Work Order ID 127367

Item Name: Clamp

DRAWING NO. D3041	TITLE CLAMP	REV. C	DART AEROSPACE LTD ENGINEERING ORDER		D.E.O. NO. D3041-C-1	SHEET NO. SHEET 1 OF 1	SCALE NTS
DRAWN ADS	CHECKED	MFG. APPR.	APPROVED		DE APPR.		
DATE 09.03.04	DATE 09.03.12	DATE 09.03.12	DATE 09.03.13		DATE 09.03.13

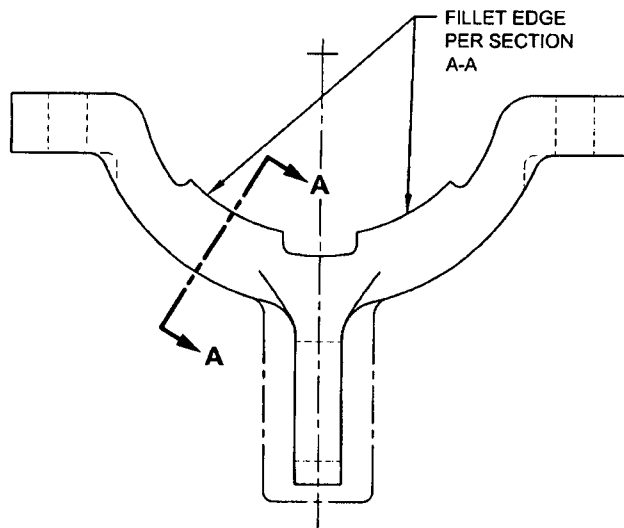
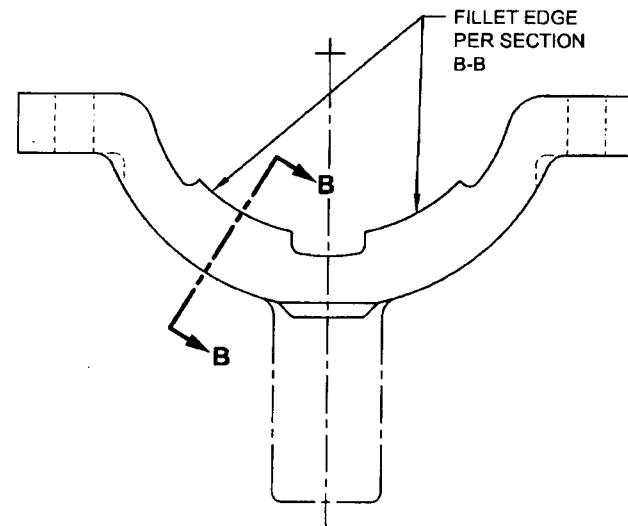
ADD FILLETS TO -1/-3/-5/-7 PER SECTIONS A-A AND B-B TO PREVENT CHAFING OF RUBBER CUSHIONS AS SHOWN:

R0.060 MIN - R0.10 MAX
2PL
